## Determination 2017/019

# Regarding a reduction in the number of personal hygiene facilities in a school building undergoing alterations at Cain Street, Parkside, Timaru

### Summary

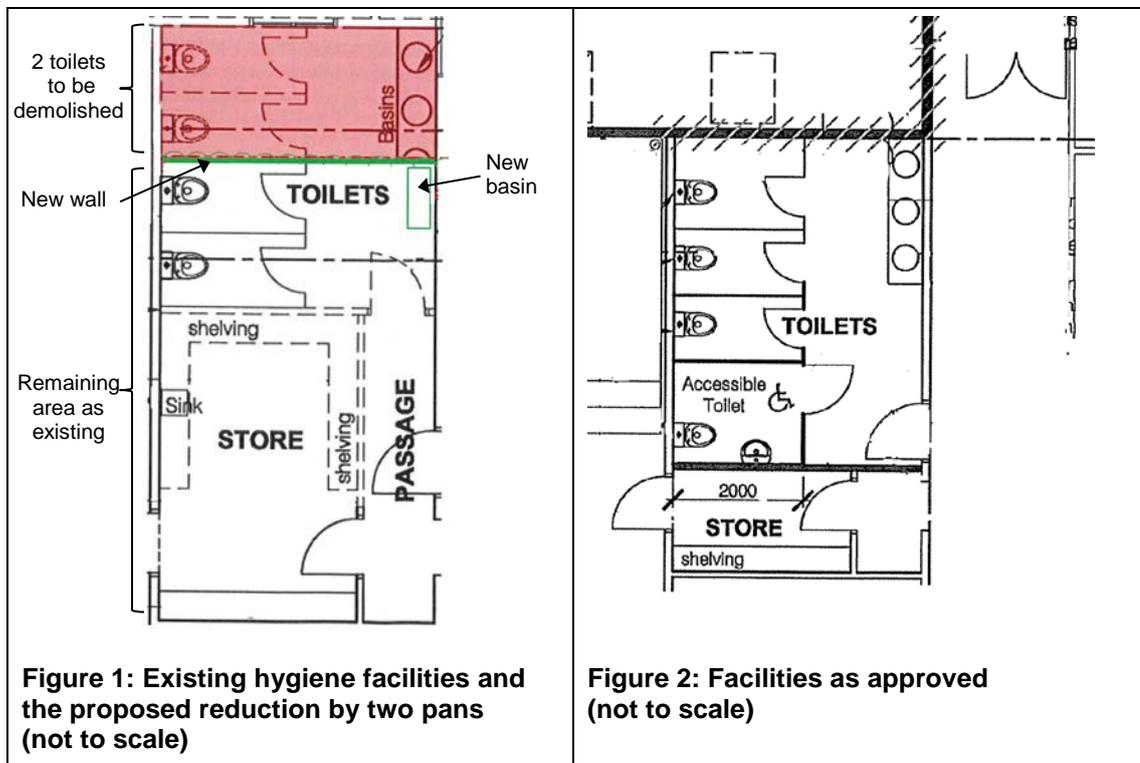
- 2.1.2 Adjacent to the MLE block is a toilet block and storage room – and it is this toilet block that is the subject of the determination. The existing personal hygiene facilities in the toilet block include four toilets, none of which are accessible, and three basins. See Figure 1 below.

- 2.1.3 The agent had initially applied for the building consent based on plans that reduced the number of pans in the MLE toilet block from four to two ‘to allow for the construction of a wall to increase the size of the classrooms’ (as indicated on Figure 1 below). The authority did not accept the proposal to reduce the number of toilets (refer paragraph 3.3).

- 3.3 On 28 April 2016, after a site visit, the authority emailed the agent advising that the removal of the toilets was 'unreasonable for the number of classrooms/library that uses these facilities'. The authority required either the toilets remain or be reinstated somewhere within the same classroom block. The authority followed this up with a letter dated 28 April 2016, which stated (item #10):

The removal of the two toilets attached to the MLE Classroom block is not reasonable practical (sic). These toilets are servicing a large area of the school and we have considered it unreasonable to remove them. Provide revised plans.

- 4.3.3 The agent also responded on 28 February, accepting the draft determination and providing a sketch of the proposed toilet layout (which I have included as figure 1 in this determination).

6.1 In accordance with section 188 of the Building Act 2004, I hereby determine that the proposed alteration reducing the number of personal hygiene facilities in the MLE toilet block to two toilets complies with clause G1 of the Building Code to the extent required by section 112 of the Act in respect of the school complex.
